**LEXINGTON-FAYETTE URBAN COUNTY
GOVERNMENT CONTRACT CHANGE ORDER**

Date:	April 8, 2016
Project:	Fire Station #2 Replacement
Location:	Lexington
Contract No.	013-2016
Original Contract Amt.	\$4,618,900.00
Cumulative Amount of Previous Change Orders	\$0.00
Percent Change - Previous Change Orders	0.00%
Total Contract Amount Prior to this Change Order	\$4,618,900.00
Change Order No.	1

Work Changes Proposal Request No. 1 Revised

Project: 13117 Lexington Replacement Fire Station No. 2
City Job No. 161-2015/038-2016

Project No. 13117
 Owner/Project No. 161-2015
C-201
 Lexington
 Replacement Fire
 Station No. 2
 1278 Escalade Drive
 Lexington, VA 24305
 Storm Sewer
 Profiles
 Revision: Δ REVISION SHEET
 Issue Date: 10/23/2015

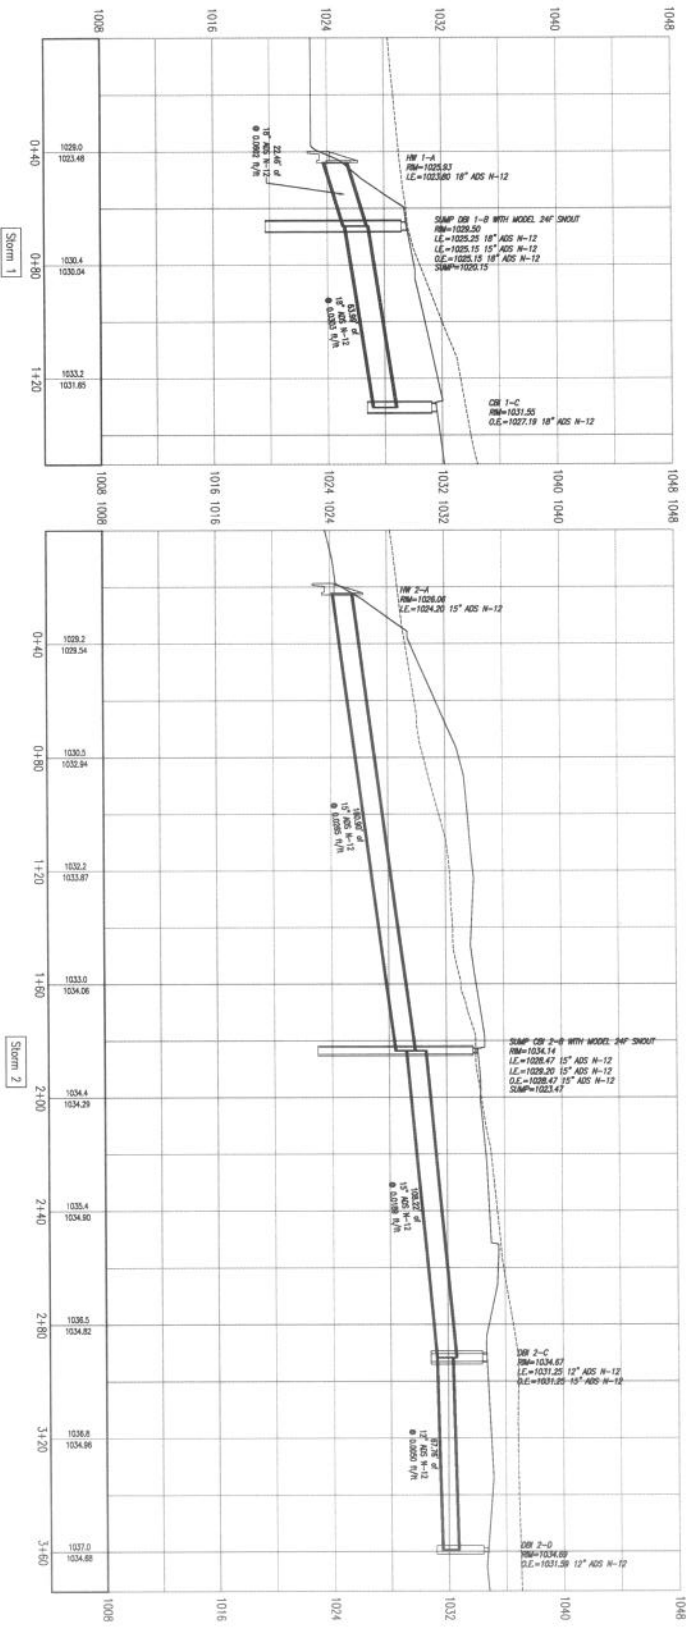
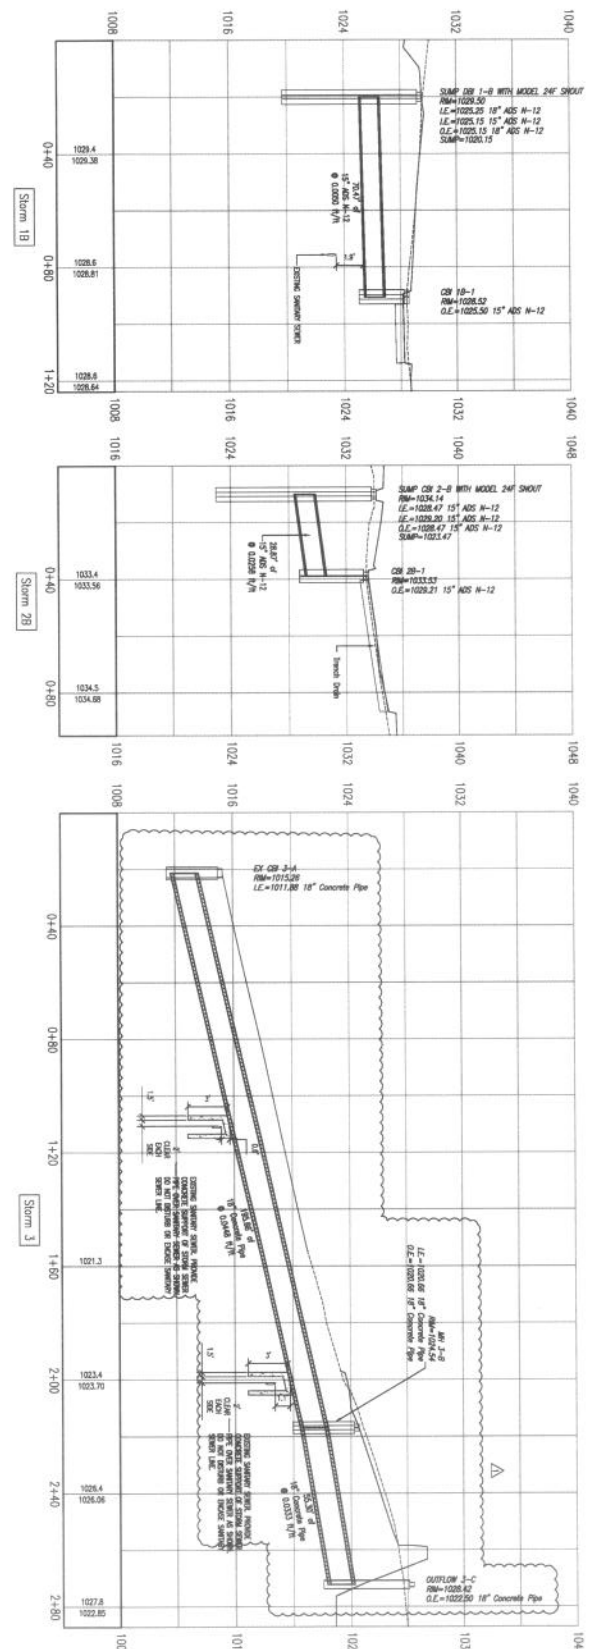
1. Per the City review and inability to gain an easement from adjacent property owner, Provide itemized pricing to modify storm sewer as shown in the attached updated sheets C-102 Grading and Drainage Plan and C-201 Profiles.
2. Per contractor request in RFI 2, please submit credit pricing to use the following piping for sanitary piping below slab and on the exterior for City to review for consideration.
 - SDR 11 piping in lieu of heavy duty cast iron piping for all exterior sanitary sewer piping
 - Schedule 40 PVC piping in lieu of Cast Iron piping below slab.
3. Per City request, please submit itemized pricing to add CMU base course(s) to Patio Footing on East side to bring even with patio slab and adjacent grade as discussed at the Progress Meeting on 3/31/16.
